**Duane Arnold Energy Center**

Response to Request for Additional Information Related to the Relief Request for  
Drywell Stabilizer Examinations

**Response to Request for Additional Information (RAI) Related  
to the Relief Request for Drywell Stabilizer Examinations**

Blowup #1

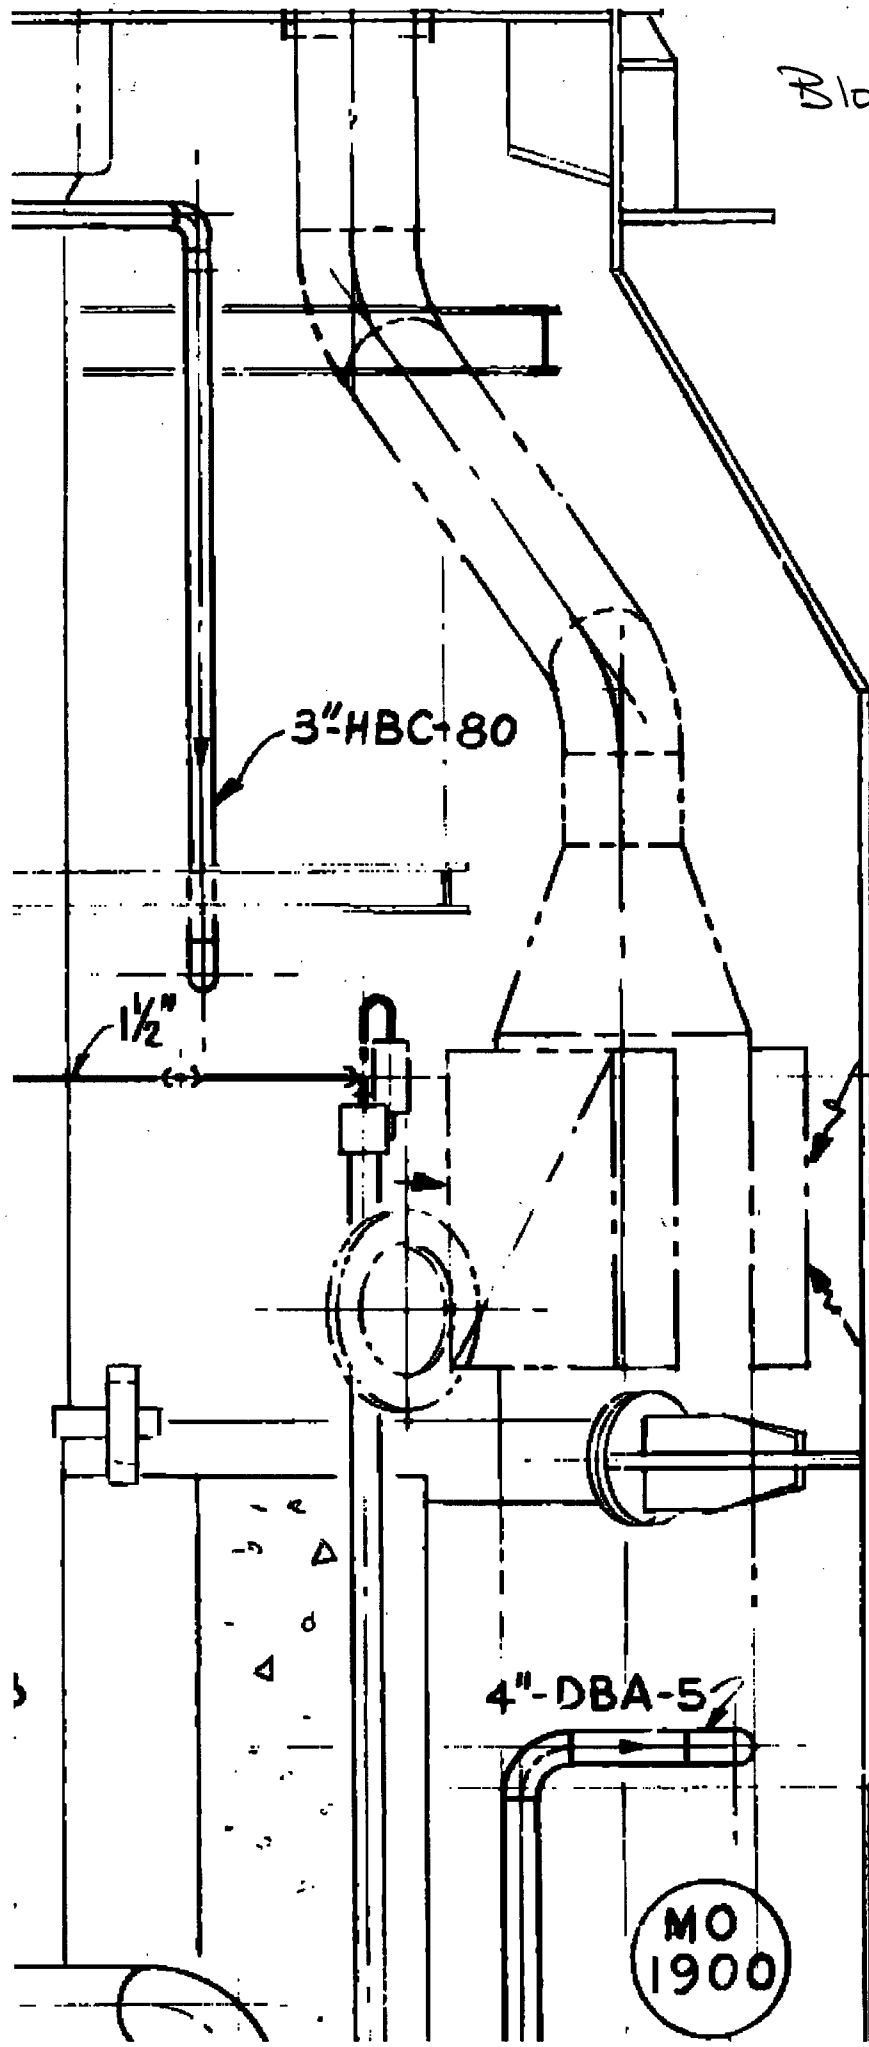
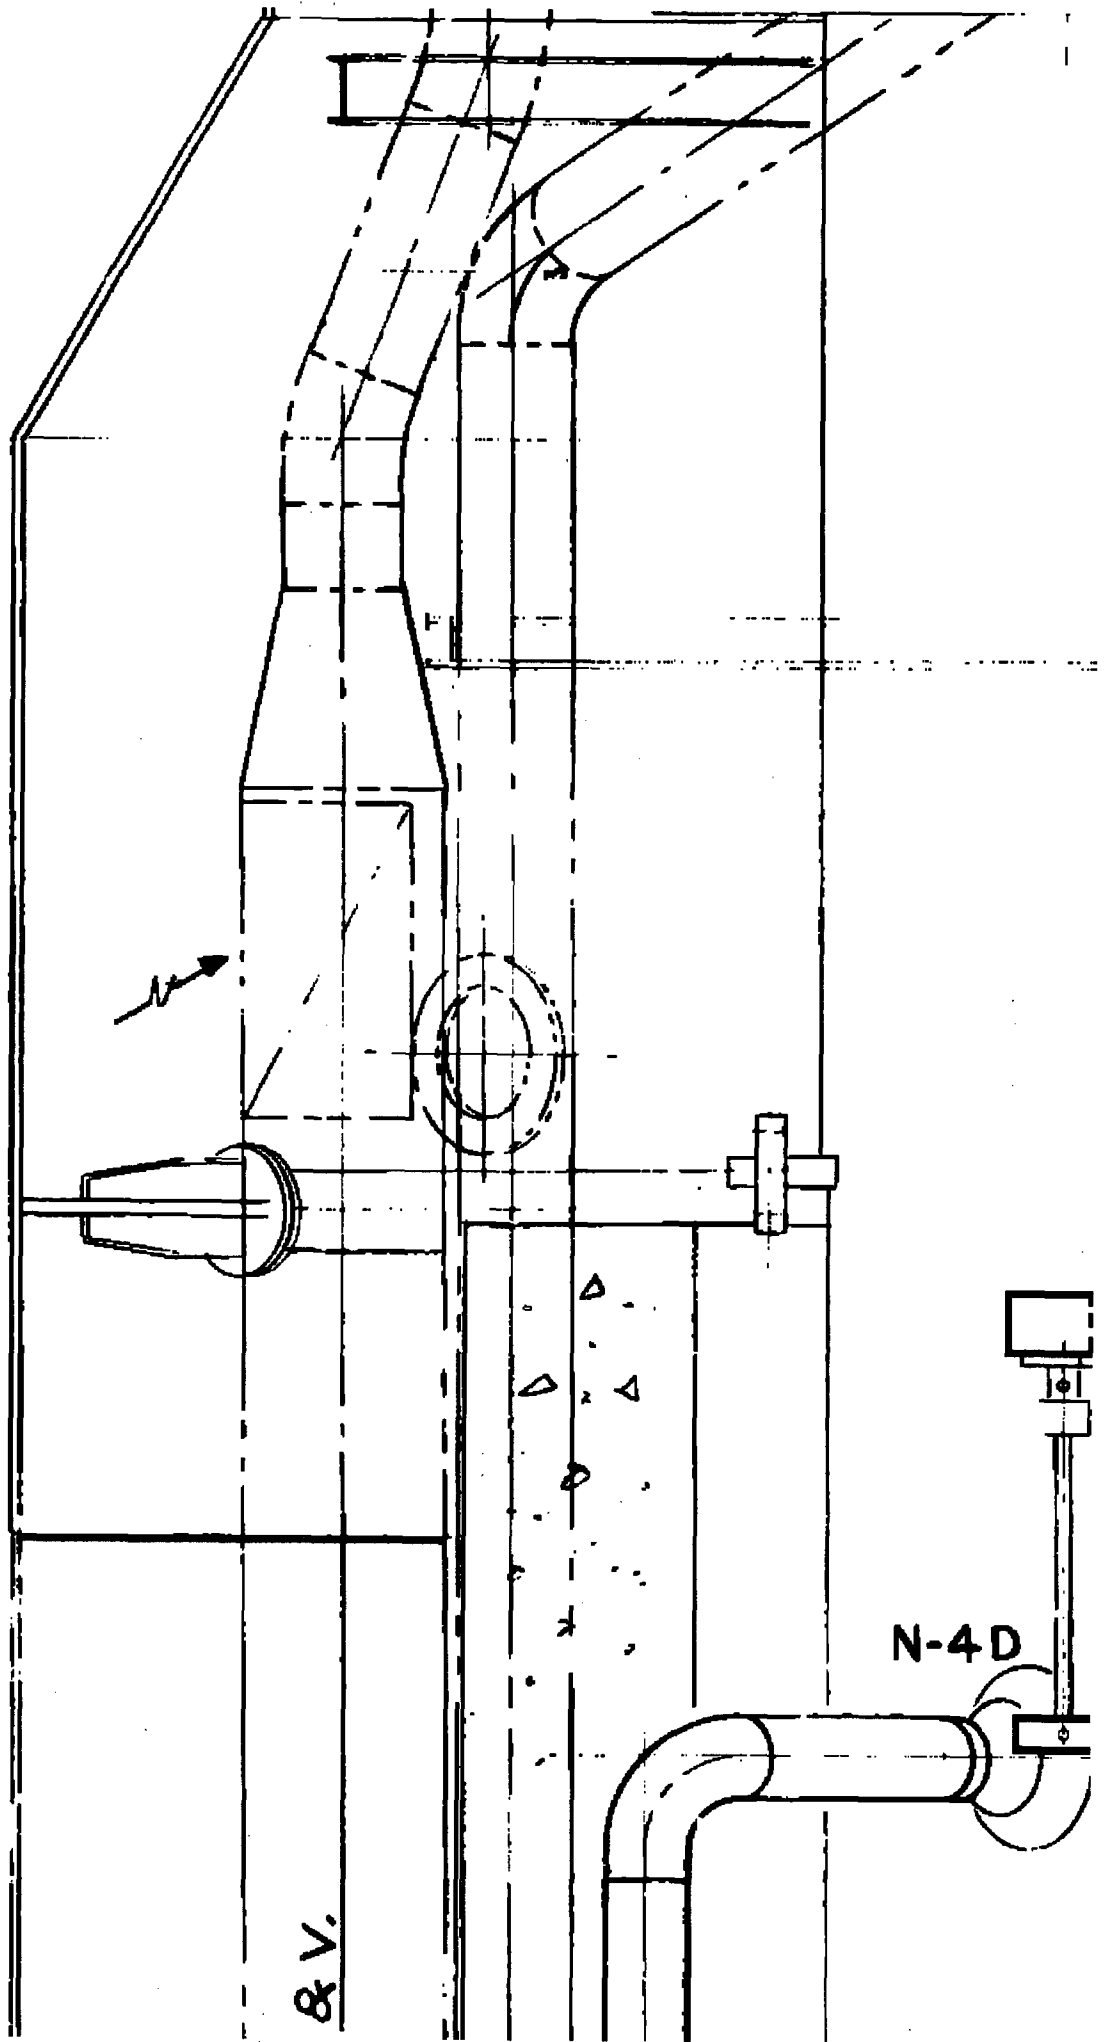
Please provide relevant drawings that show the relative location, structural configuration and general arrangement of Drywell Stabilizers X-58C and X-58G and the drywell coolers to enable the staff to understand the nature of the interference from the upper elevation drywell coolers that prohibits access for removal of the bolting and manhole covers for examination of Drywell Stabilizers X-58C and X-58G.

Attached are three drawings (BECH-M004, BECH-M341, and BECH-M041) in Enclosure 2. Blowups of sections of BECH-M341 are also provided in Enclosure 2. Drawing BECH-M004 provides the plan view of the drywell at elevations 812 feet 0 inches and 833 feet 6 inches. Drawing BECH-M341 shows the elevation view of the drywell as well as the drywell cooler location and size compared to the other components in the drywell. Drawing BECH-M041 shows the locations of the manholes. As shown in the three drawings and the attached blowups, in conjunction with the photographs already submitted in Reference 1, the drywell coolers interfere with the removal of the Stabilizer manhole covers, thus preventing the visual examination of the integral attachment on the outside of the containment.
